Grid Service Charges 2012-2013:

Phase 2 - Assessment of Capital and Operating Expenditure

Grid Service Provider: Seqwater

PHASE 2 – ASSESSMENT OF PRUDENCY AND EFFICIENCY OF OPERATING AND CAPITAL COSTS – SEQWATER

■ **Figure 7 Luggage Point Advanced Water Treatment Plant specific power versus production**

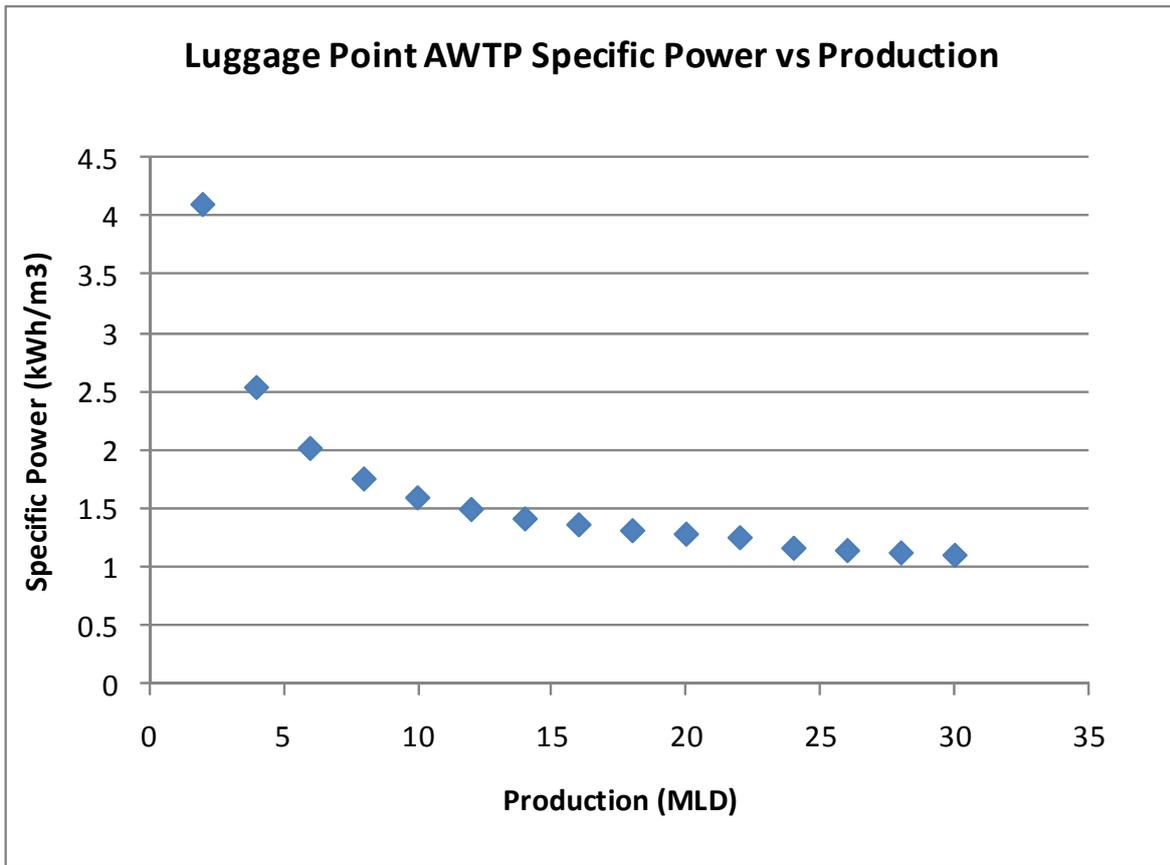
The proposed electricity budget for the Luggage Point Advanced Water Treatment Plant for the 2012/13 operating period is \$ 1,651,999 for 3,858 ML, which equates to \$ 428.26 per ML. However, this is an interim figure. The plant is currently eligible for notified tariffs, but rule changes from July 2012 will mean that electricity must be procured under a market contract. Seqwater has proposed that the Variable Operating Charge for 2012/13 be based on actual contracted energy prices once these are known.

The electricity forecast in last year's submission for the 2011/12 period was \$ 1,041,000 for 7300 ML which equates to \$ 142.60 per ML. The second quarter estimate of electricity costs for the same period is \$ 1,114,222 for 3,650 ML, resulting in a unit cost of \$ 305.27 per ML. This increase is mainly due to the fact that the original unit rate was based on a much larger water throughput, which would have required long production cycles or even continuous operation. Because there are major energy costs associated with starting up and shutting down the plant, as well as some fixed energy costs remaining the same regardless of production levels, a smaller volume leads to significantly higher unit costs. The increase in cost per unit volume between the 2011/12 and 2012/13 periods (using the most recent forecasts) is around 40%.

Figure 7 uses historical data from the plant to show how the power per unit volume increases sharply as total purified water production decreases.

■ **Figure 16 Comparison of options by their NPVs (Source: June 2011 Business Case Review)**

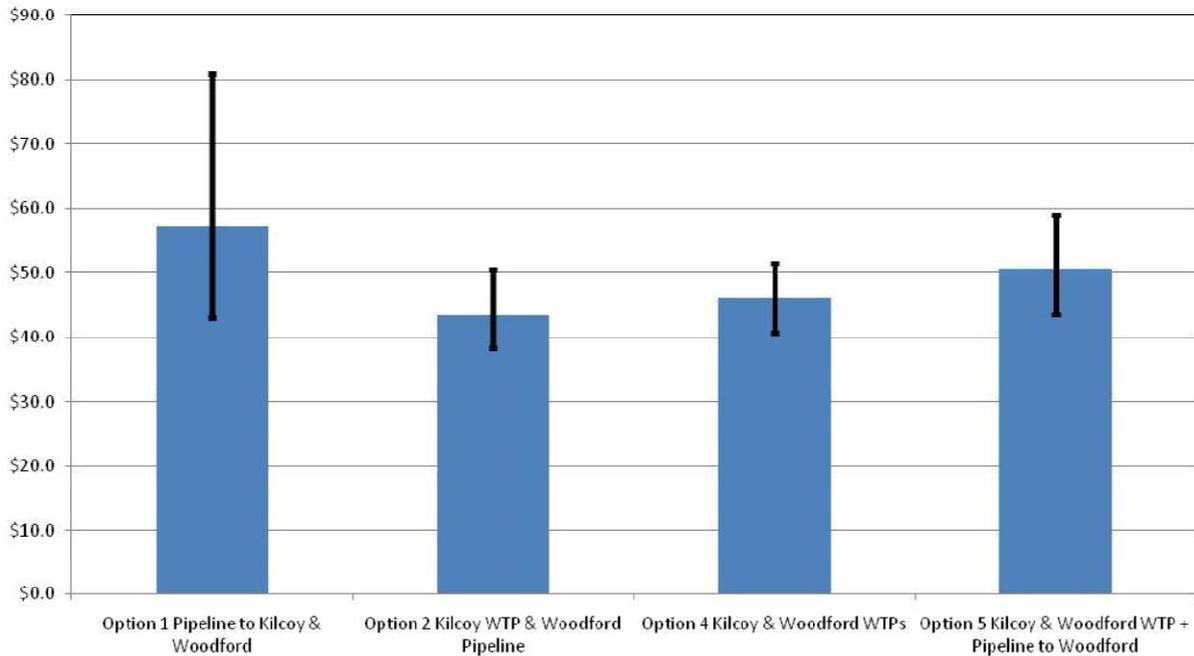
A full evaluation of Option 3 was not presented within the Business Case Review Report due to it being the most expensive option presented, resulting from the following:

As shown in **Figure 16**, below, Option 2, i.e. the scope originally proposed for this project, was found to still be the most cost effective option from the NPV analysis conducted by Seqwater, even using the increased project costs.

Figure 15: Industry benchmark water treatment plant costs.

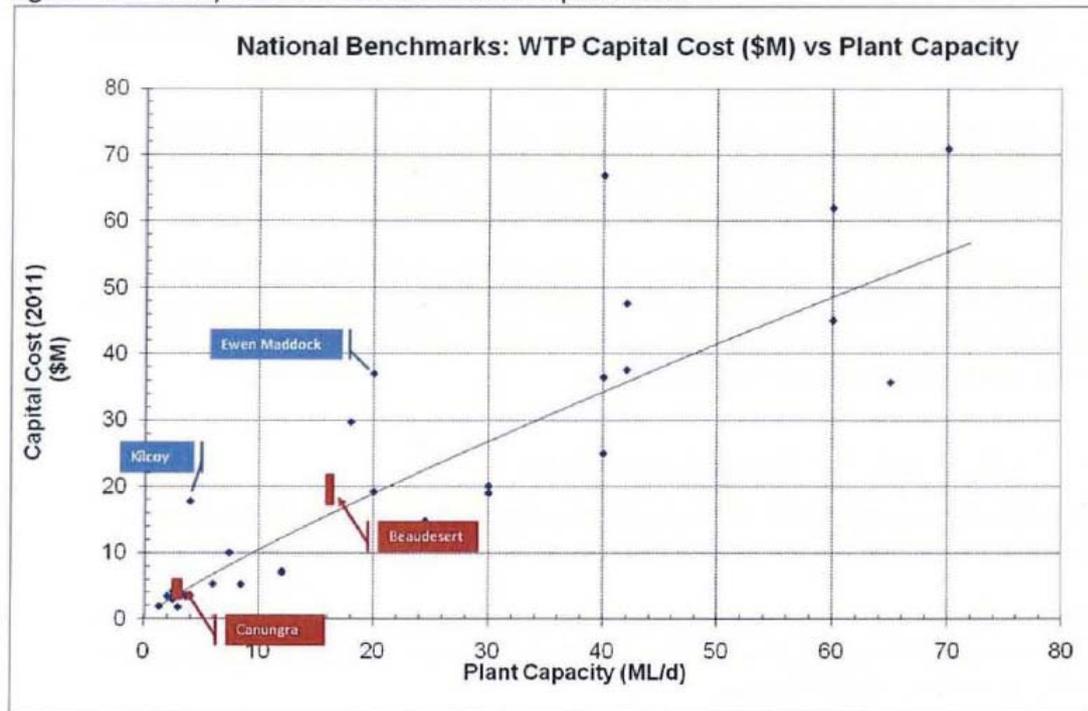
The recommended discussions have not occurred, and no further information or advice has been provided about the concerns raised. However, we note that information provided by Seqwater as part of a separate planning process reflects that the Kilcoy Water Treatment Plant is more expensive than benchmark industry rates (see Figure 15, comments in original).

■ **Figure 19 Water Demands and Boonah – Kalbar Water Treatment Plant treatment capacity**

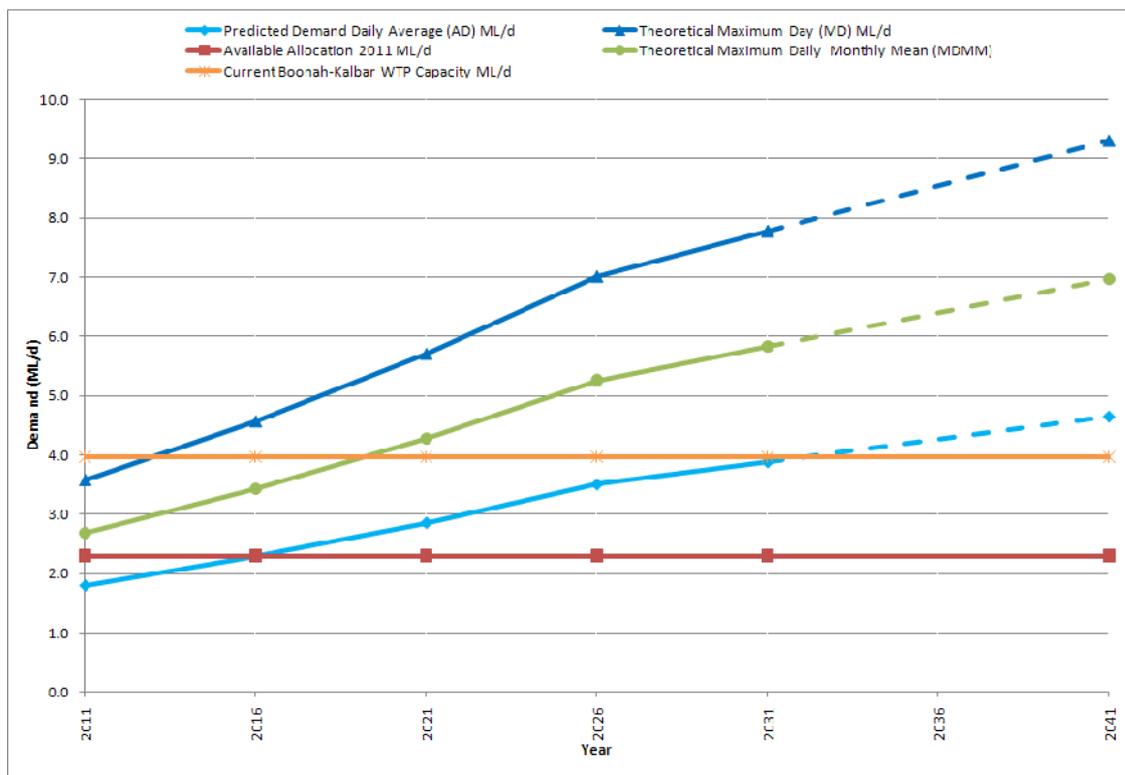
With regard to capacity, whilst the plant has a nominal capacity of 4 ML/d, it can only reliably be operated when attended and consequently has an effective capacity of 1.6 to 2.0 ML/day based on 8 – 10 hour shifts.

From the graph included within the SEQ Water Grid Managers submission, the average day demand is 1.5 ML/d to 1.6 ML/d and the MDMM would therefore be in the order of 2.24 ML/d. This illustrates that based on 8-10 hours operation, the facility is capacity constrained. The automation of the plant is the basis of Project 2 to allow increased operational capacity.
